6 September 2021

Gray Matter Ltd
2 Alfred Street
PO Box 14178
Hamilton, 3252
Tel: 07 853 8997

PC7 ROTOKAURI NORTH – UPDATED TRANSPORTATION REVIEW

Figure 2: Updated Structure Plan

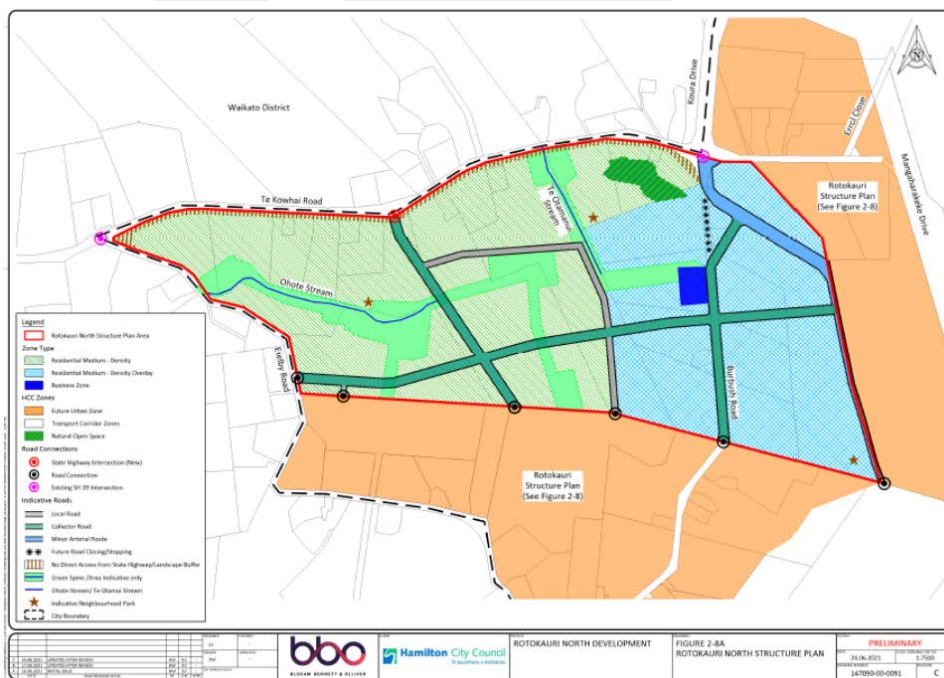
PC7 seeks to rezone 140 hectares of land to medium-density residential, allowing for the development of up to 2,000 dwellings, plus a neighbourhood commercial centre (Business 6 Zone). The revised proposal for the road hierarchy is shown on Figure 2. The key differences between the previously proposed structure plan layout (as shown on Figures 1, 2 and 3 of our August 2020 review) and the current proposal are:

- = Removal of the Collector 2/ SH39 intersection; and
- = Realignment of previous Collector 2 and identification as a local transport corridor.

We understand that the ICMP has been revised to a predominantly piped network which should address our previous concerns relating to road safety impacts from design of swales and potential flooding. Matters identified in our earlier assessment may still be relevant for consideration during detailed design (e.g. cover between stormwater culverts, road pavement and underground services).

The approach to specifying transport corridor cross-sections has changed. All reference to cross-sections specific to this zone have been removed. The proposal will rely on the form of transport corridors described at Tables 15-6a) and ii).

Figure 3: Network modelled in the 'Without Minor Arterial' scenario

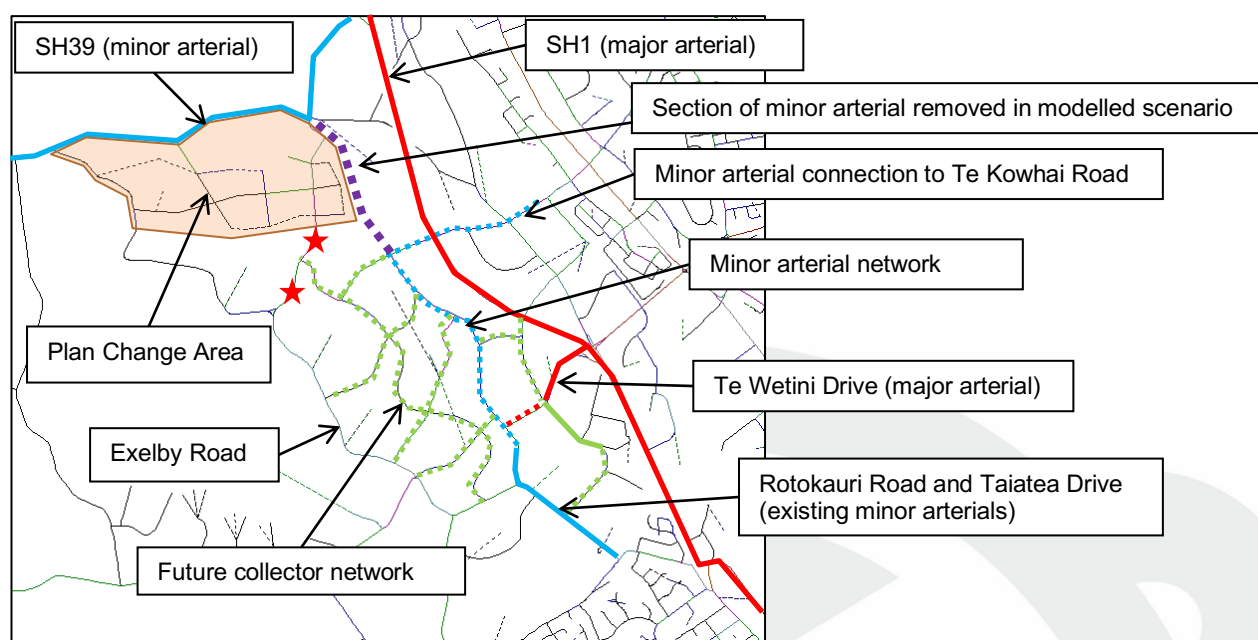
It is important to understand that the 2041 ‘without’ scenario only excludes the part of the minor arterial within the structure plan area, other connections to Te Kowhai Road East and Taiatea Drive remain in the model. An annotated version of the modelled network is provided below. In this scenario traffic can use the future collector and minor arterial network to connect to Te Kowhai Road and avoid using Exelby Road to the south.

The most notable changes between the modelled 'with' and 'without' minor arterial scenarios are:

- = The without scenario has 40% less traffic on the southern portion of the minor arterial (location F2) as a result of traffic transferring to Exelby Road (location E) and the parallel north-south collector road.
- = Traffic on the future minor arterial connection to Te Kowhai Road (location H) decreases in the AM and increases in the PM peak.
- = Traffic on SH39 (Koura Drive) increases by 10% (an additional 100veh/hr).
- = Traffic on Exelby Road increases by 15% (an additional 100veh/hr).

The model outputs (refer to Attachment A) show that this east-west minor arterial (location H) carries 660-870veh/hr with the minor arterial and 580-930veh/hr without the minor arterial. This indicates that this connection plays a significant role in connecting Rotokauri to employment at Te Rapa. Without this connection the traffic volumes on SH39 and the Burbush/ Exelby Road corridor will increase significantly as 500-1,000veh/hr would be redistributed elsewhere.

Figure 6: Daily Traffic Volumes on Burbush Road

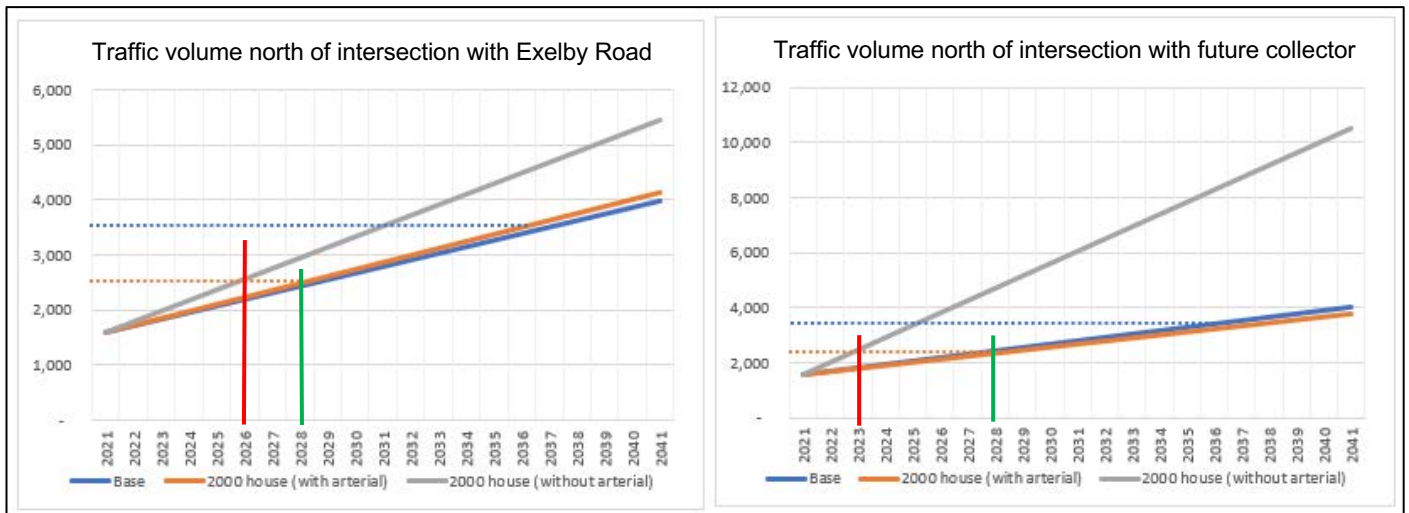
Commute provided¹² the following graphs of daily traffic volumes at two locations on Burbush Road. The locations are either side of the future collector link to Te Kowhai Road and are shown as red stars on Figure 3.

This assessment is based on assumptions including a linear rate of growth over 20 years and the relationship of peak hour to daily volumes. Assuming a linear growth rate, the graphs indicate that a volume of 2,500veh/day is reached after 2-5 years of development (indicated by the red vertical line). This equates to development of 200-500 dwellings without the minor arterial. In both the base model and with the minor arterial in place this increases to 8 years (or 800 dwellings). The implementation plan proposes higher thresholds of 600 and 1,500 dwellings.

In our view the triggers for widening on Burbush Road and Exelby Road provided in the Implementation Plan are too high. Due to uncertainty in delivery of the minor arterials, along with uncertainty in staging and location of the proposed development we consider that widening of Burbush Road and Exelby Road (south of Burbush Road) should be triggered by 200 dwellings without the minor arterial and 800 dwellings with the minor arterial.

Figure 7: Daily Traffic Volumes on Exelby Road

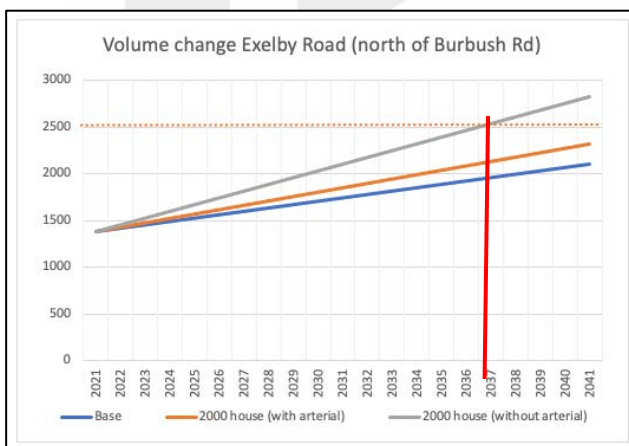
The modelling predicts less traffic on the section of Exelby Road between SH39 and Burbush Road (west of the plan change area). In the scenario without the minor arterial and based on a threshold of 2,500veh/day, approximately 80% of the development could take place prior to widening. I am concerned that the staging (both size and location) will influence the traffic volumes on Exelby Road and this is not reflected in the modelling. As discussed earlier we have concerns with this corridor including the lack of sealed shoulder, narrow sealed width, poor horizontal and vertical alignment, and in my view an upgrade to this rural portion is likely to be triggered by safety concerns (rather than efficiency effects) which would not be fully addressed by the proposed widening.

Figure 10: Traffic Volumes and Warrant at Burbush Road/ Exelby Road intersection

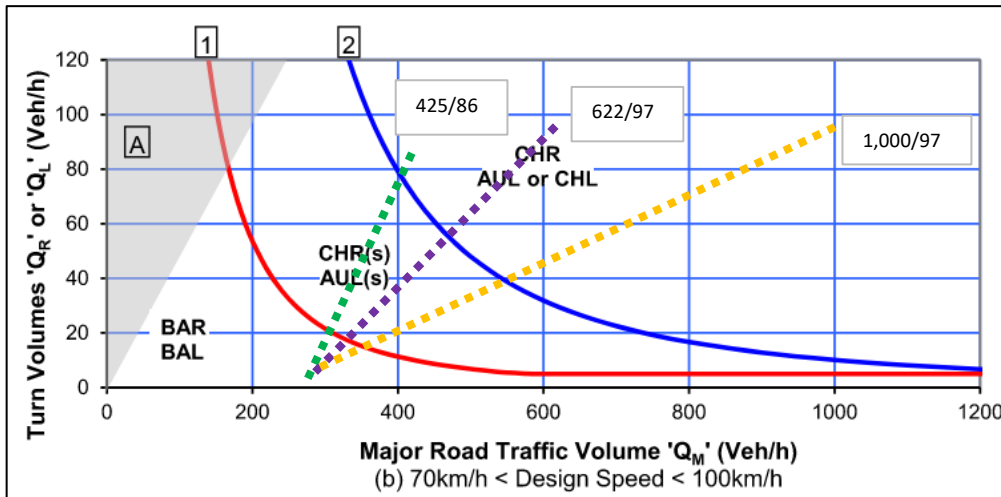
Plotting these through and turning volumes on the figures for Austroads warrants¹⁴ indicate a right turn bay is warranted with a turning volume of around 15-20veh/hr and the through volume is around 300veh/hr. Assuming a linear growth rate and without the minor arterial a right-turn bay is triggered with around 20% of total development¹⁵ or 400 dwellings.

The concept provided at Figure 22 of the ITA Addendum does not show the proposed right-turn bay. Construction of improvements to the Burbush Road/ Exelby Road intersection will be challenging as the intersection straddles the HCC/ Waikato DC boundary and Burbush Road is located very close to the road reserve boundary which may impact on the ability to construct an Austroads compliant right-turn bay. It is unclear if complying sight distance can be provided for a right-turn bay at this intersection due to the vertical and horizontal geometry.

In my view the 600 dwelling trigger in the proposed Implementation Plan is too high and the intersection improvement appears warranted following development of around 400 dwellings. In my view intersection improvements should be coordinated with widening of the Burbush Road/ Exelby Road corridor (i.e. following development of 200 dwellings).

Figure 14: Recommendations for Off-Road Walking and Cycling Facilities

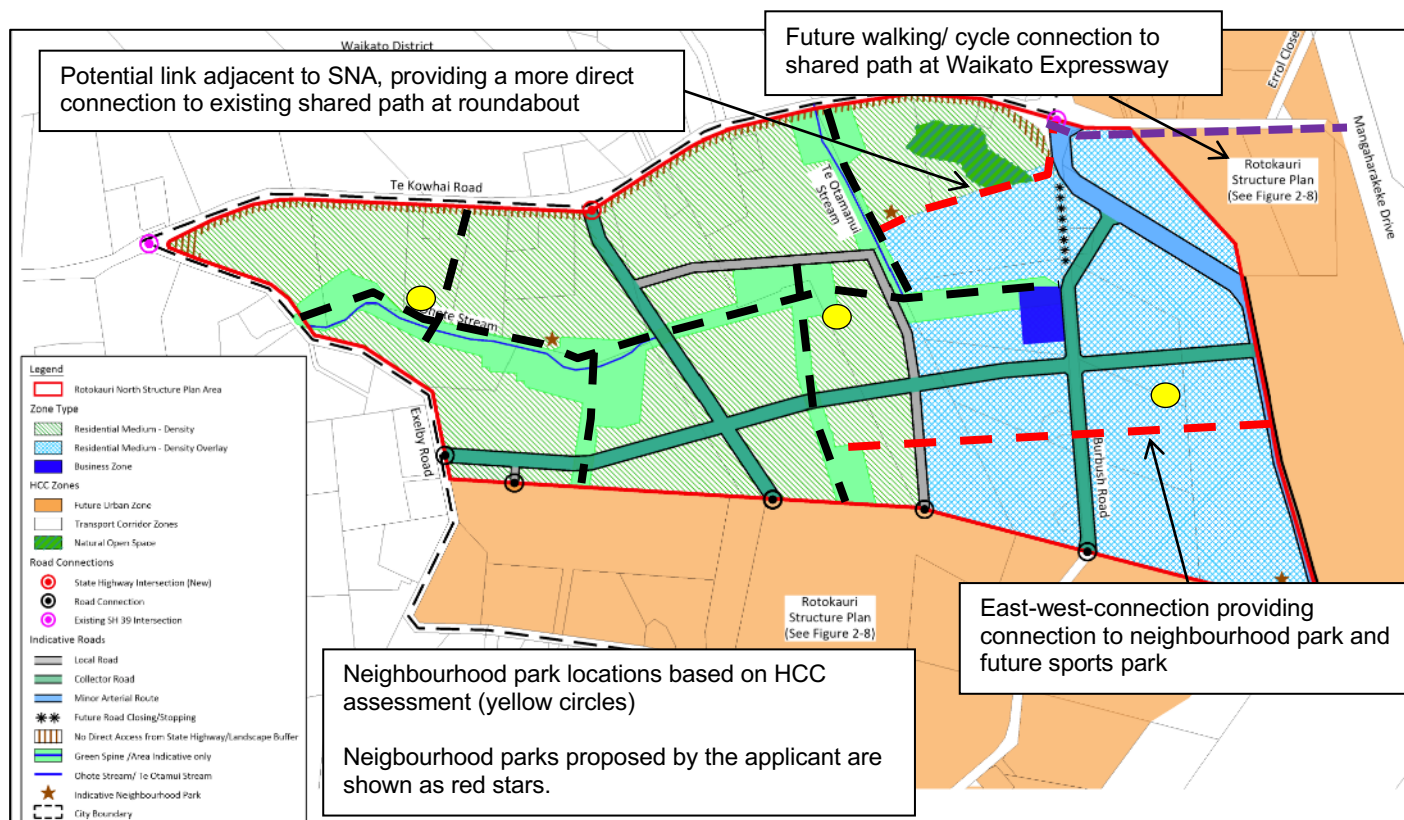
To achieve Council's objectives for mode shift and connectivity the structure plan should include a network of off-road paths connecting open space, neighbourhood parks, sports park, the business zone, future land uses such as schools and the minor arterial network. The green spine provides the best opportunity to provide this off-road facility, noting that connections should be provided across the streams/waterways to prevent these features becoming barriers to walking and cycling. Detailed design will need to consider CPTED matters such as lighting and passive surveillance.

The proposed minor arterial designation includes separated walking and cycling facilities on both sides of the arterial with connections to the shared path on the western side on the Waikato Expressway at Te Kowhai Road/ Errol Close in the north and at the Te Kowhai Road and Chalmers Road underpasses further south of the site. The off-road facilities within the structure plan should provide direct connections to these strategic paths which are external to the site.

I understand that HCC has proposed changes to the location of the neighbourhood parks which will influence the location of an off-road path network. There may also be other limitations on path locations identified through the ICMP. I recommend that an off-road network be identified on the Structure Plan map. An indicative network is shown below. The related District Plan provisions should provide for a degree of flexibility to allow the routes to match the detailed subdivision layout and site specific constraints identified during detailed design.

Figure 15: WRC Preferred PT Route

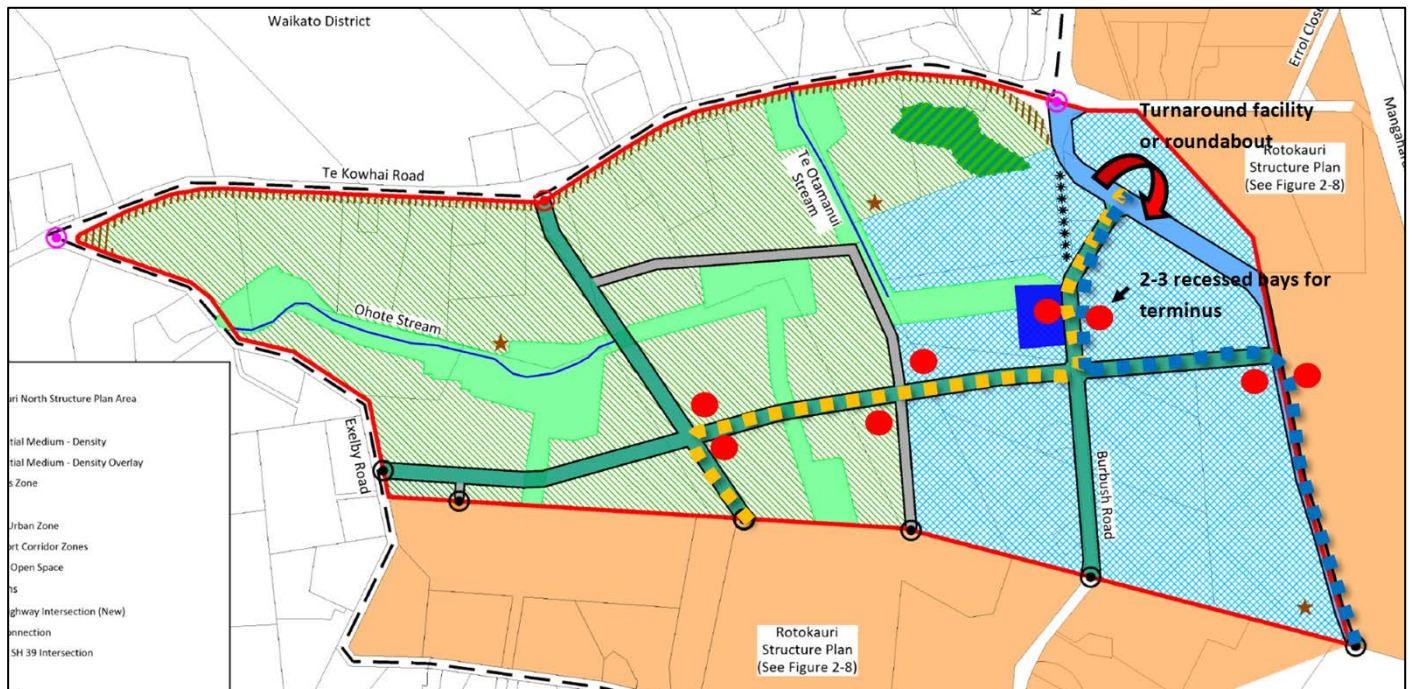
WRC previously provided two options for provision of PT services to Rotokauri (refer to Appendix 5 of the HCC Report on technical planning and infrastructure matters). They have provided²¹ an updated view based on the revised structure plan. The sketch confirms the minimum infrastructure requirements at the terminus. I note that it would be preferable for the turnaround facility to be provided within the structure plan area, rather than at the minor arterial intersection which is likely to be signalised. The proposed provisions (Rule 3.6A.4.6) require PT infrastructure such as bus stops to be provided as part of developing new transport corridors. We recommend that the PT routes and bus stops identified by WRC are included on the structure plan map.

We understand that there is no public transport funding for out of sequence developments. Therefore, any initial services are likely to be demand responsive public transport services, which typical comprise flexible routes and scheduling, use of small or medium vehicles and can provide door-to-door services. An option to provide funding for a demand responsive service would be through a Private Developer Agreement between the Requester and WRC.

In summary, the out of sequence nature of the plan change does not initially support the provision of public transport services and will likely rely on private vehicle travel unless a funding agreement for demand responsive services is in place. Relying on the private vehicle will not reduce or manage vehicle kilometres travelled (VKT) or reduce carbon emissions. Unless infrastructure and funding constraints are resolved it appears unlikely that an effective public transport service can be provided to the early stages of the development.
